1 APPLICATION SUMMARY

The purpose of this report is to assess an application for a development permit for a Material change of use (Code assessable) to establish a Warehouse at 60 Stapylton Jacobs Well Road, Stapylton or more specifically future lot Lot 205 within Stage 2 of the Vantage Industrial Estate.

Figure 1: Proposed site plan (source: HLA architects)

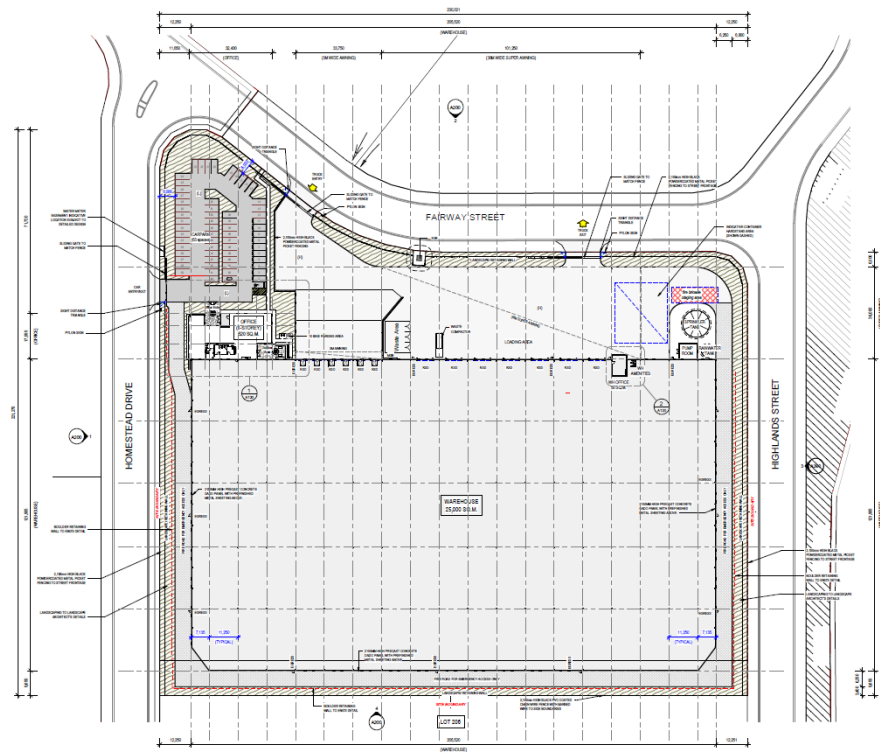
The proposed development includes a Warehouse with a GFA of 25,520m². Based on the GFA and the use the Table to Acceptable Solution AS16.1 requires the development provides 258 parking spaces. The proposed development includes the provision of 63 carparks.

"To comply with Acceptable solution AS8.1.2 of the M38 Industrial Estate Place Code, the development must provide a minimum of 258 car parking spaces. The submitted drawings show a total of 63 car parking spaces. Compliance with AS8.1.2 is therefore not achieved. Consideration must be given to PC8 of the M38 Industrial Estate Place Code.

The applicant stated that the development will operate with up to 40 staff, with 30 working in the warehouse and 10 in the office. There will be minimal staff operating the facility overnight and therefore the proposal is not expected to have a significant shift overlap period. On that basis, it is considered that the proposed parking supply of 63 spaces will satisfactorily cater for the peak parking demands of the site, including during shift changeover periods. A condition of approval has been recommended accordingly to ensure compliance with PC8 of the M38 Industrial Estate Place Code."

Based on the above assessment it is considered the development complies with Performance Criteria PC8 of the M38 Industrial Estate Place Code.

Figure 2: Proposed elevations (source: HLA architects)

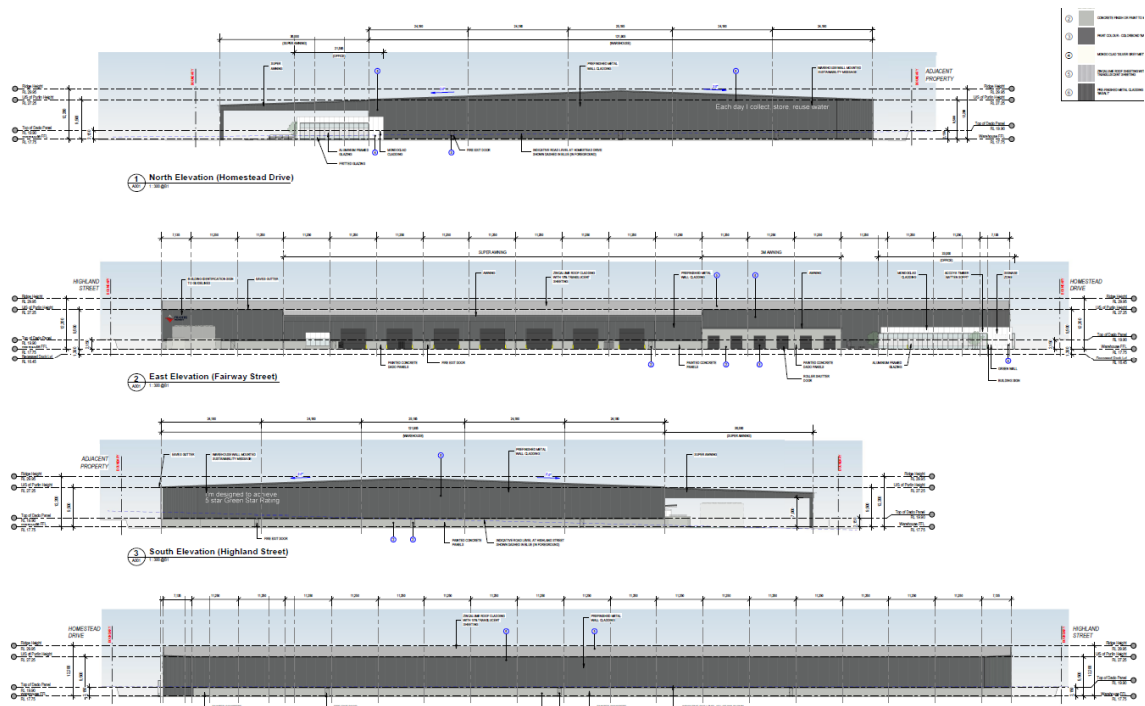
As the entire site is still within the early stages of development, few developments have been completed. It is noted that the future lots directly surrounding the proposed development remain vacant, as such there are no nearby buildings for the proposed development to complement which is a requirement within Acceptable Solution AS19.1 and AS19.2. For transparency, officers have provided assessment against Performance Criteria PC19.

The proposed development is part of a preliminary approval coordinated for the Vantage Industrial Estate and aligns with the design intent of the estate. The proposed building design achieves a modern finish which is representative of the emerging design intent within the estate. The desired outcome for the estate includes a standardised colour scheme which emphasises a bold contrast between built form and the landscaping works intended for the proposed development.

It is considered that the building materials, patterns, colours, massing, and proportions of the proposed development are of a high aesthetic standard and are consistent with the design intent of the Yatala Enterprise Area and the Vantage Industrial Estate.

Based on the above assessment it is considered the development complies with Performance Criteria PC19 of the M38 Industrial Estate Place Code.

Figure 5: Site plan demonstrating the separation between the loading bay and staff/ visitor car parking areas (source: HLA Architects modified by Council officers).

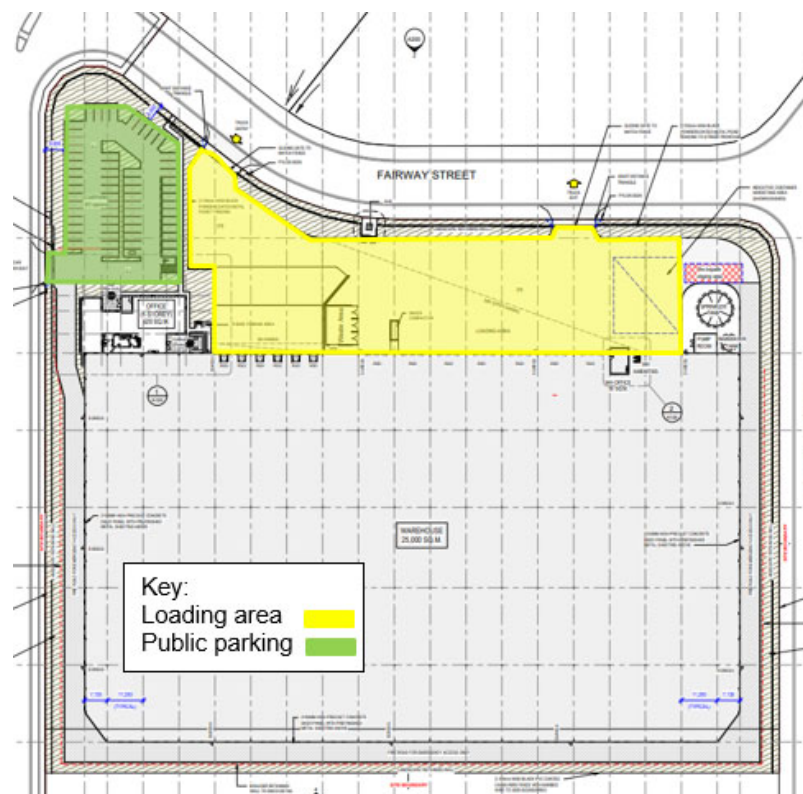
PC15: The proposed development clearly articulates a separation between public access and areas allocated for servicing the building. A single VXO accessing the site from Homestead Drive provides light vehicle access to car parking areas situated adjacent to the ancillary office entrance. The car parking area is boarded by landscaping which prevents smaller vehicles accessing the heaving vehicle service area (see figure 5).

The loading bay fronting Fairway Street is accessed by two VXOs intended for use by heavy vehicles. With the exclusion of the VXOs, the proposed loading bay area is screened from the road reserve by fencing and landscaping treatment ensuring it is separated from the public realm. It is considered that the proposed site layout achieves separation between public access areas and areas intended for servicing the building.

PC16: The proposed development includes substantial landscaping between 3.4m and 6m addressing the road frontages which is designed to soften the built form of the industrial use. Additionally, conditions are provided to ensure that any potentially visually offensive elements will be appropriately screened from the view of the street to achieve a high quality industrial appearance.

Based on the above assessment it is considered the development complies with Performance Criteria PC14, PC15 and PC16 of the M38 Industrial Estate Place Code.
